**City of Pembroke Pines
 Planning & Economic Development Department
 601 City Center Way 3rd Floor
 Pembroke Pines FL, 33025**

Agenda Date:	June 27, 2019	Application ID:	MSC 2019-12
Project:	Walmart #2591	Project Number:	N/A
Project Planner:	Cole Williams, Planner / Zoning Technician		
Owner:	Wal-Mart Stores East LP	Agent:	Jose Castro – WD Partners
Location:	151 SW 184 th Avenue		
Existing Zoning:	PUD (Planned Unit Development)	Existing Land Use:	Commercial
Reference Applications:	MSC 2018-08, ZV 2002-33, SP 2002-28, SP 97-25		
Applicant Request:	Installation of one freestanding canopy over 6 short-term parking spaces. 7 short-term parking spaces in total are proposed.		
Staff Recommendation:	Approval		
Final:	<input checked="" type="checkbox"/> Planning & Zoning Board	<input type="checkbox"/> City Commission	
Reviewed for the Agenda:	Director: 	Planning Administrator:

Date: June 17, 2019
To: MSC 2019-12 file
From: Cole Williams, Planner / Zoning Technician
Re: Walmart #2591

**PROJECT: WALMART #2591 – PICK-UP PARKING
CITY REFERENCE NUMBER: MSC 2019-12**

SHEET: **A3.0**

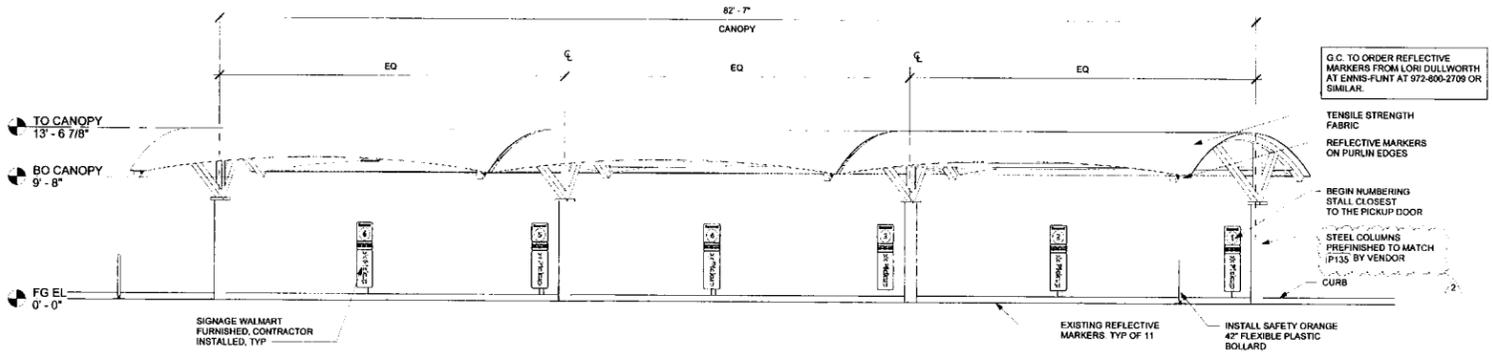
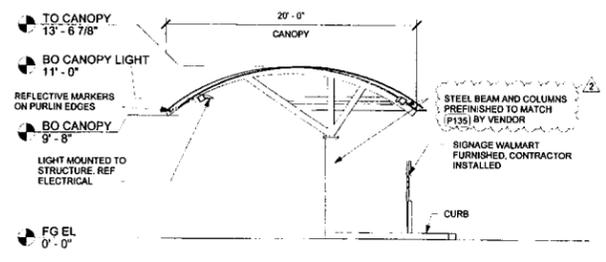
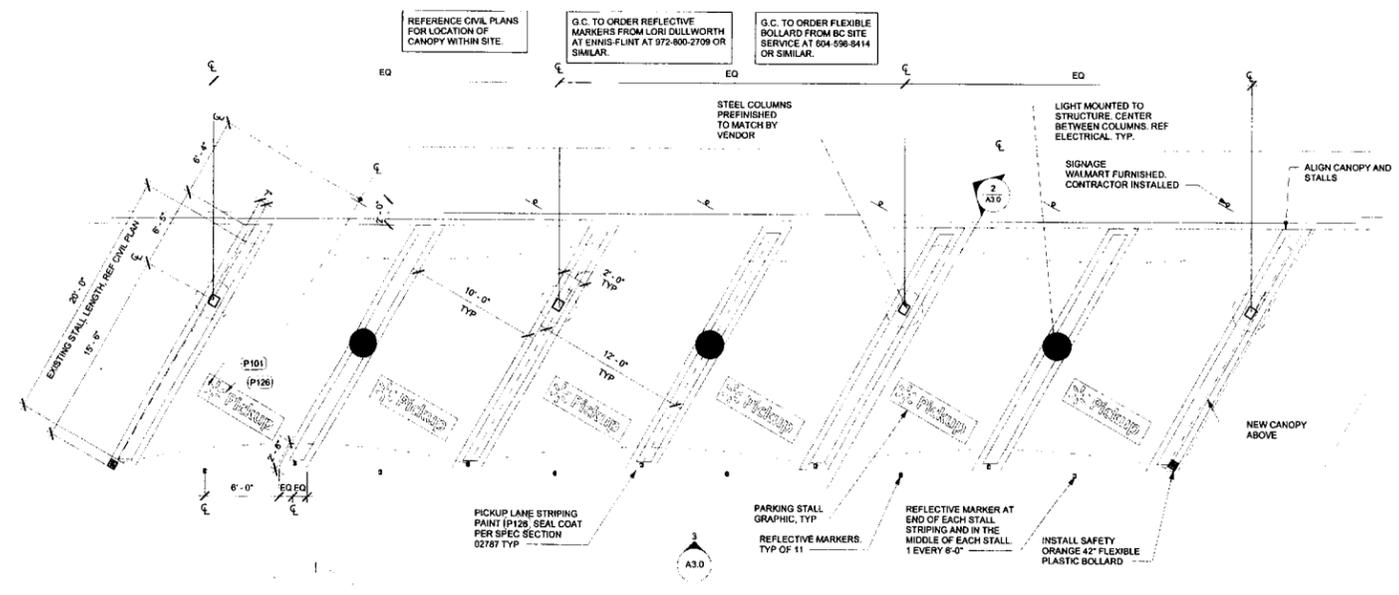
6. Short-term parking sign shall not exceed 1.5 square feet in size. **Sheet A3.0 still shows the old signage details.**
7. ~~Per City Code section 155.251. Only 1% of the total parking on site is to be used for short term parking. Currently there are 1,022 parking spaces on site, which would permit 10 short term parking space. 3 of which are used by the outbuilding tenants.~~

12. ~~The size of the canopy is inconsistent throughout the plans. Revise sheets to be consistent.~~
13. Clarify color of the canopy structure. Label all colors on the plans. **Ensure that all colors used within the finish legend are used and labeled on the plans see sheet A3.0**

Clarify all lighting under canopy as Canopy Elevation (detail #2), on Sheet A3.0, shows a “light mounted to structure”, but also has Canopy Perspective (detail #4) which shows pendant style light fixture.

Confirm lighting fixture under canopy does not extend lower than edge of canopy so it is “recessed”.

SHEET: C1.2

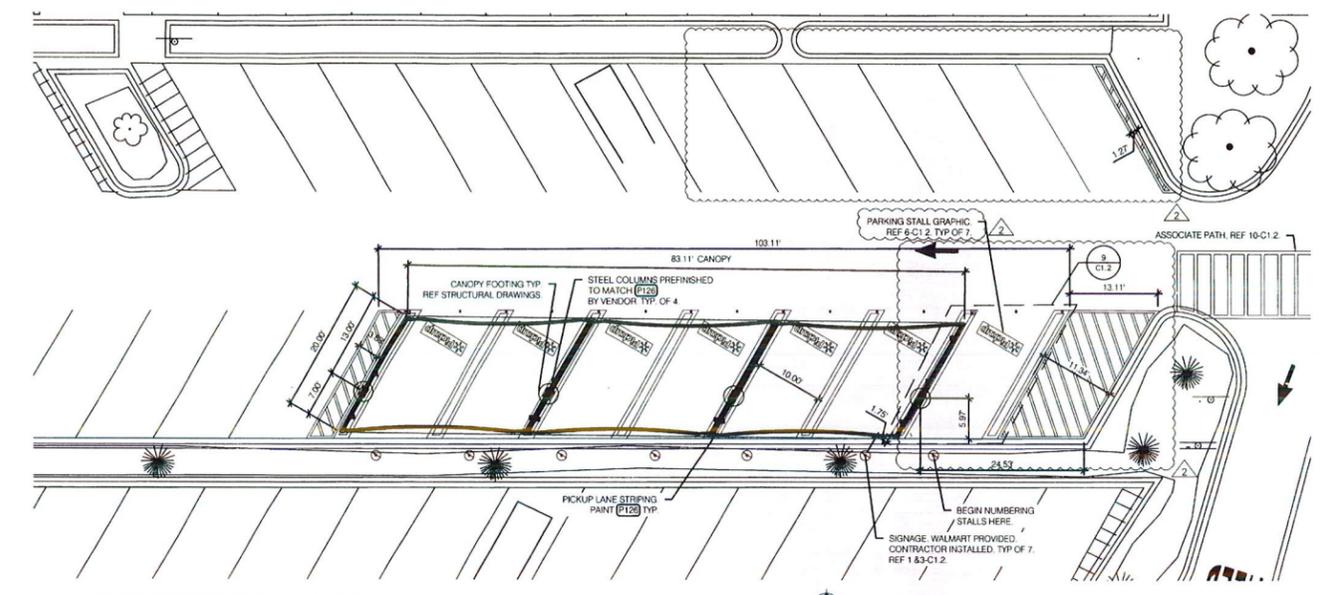
- ~~16. Provide new site plan showing all improvements~~
17. **Provide color elevation of canopy**
18. **On Sheet CP3 and CP3.1, it shows spaces 1-6 being covered, which is not consistent with the other sheets including sheet C1.2**
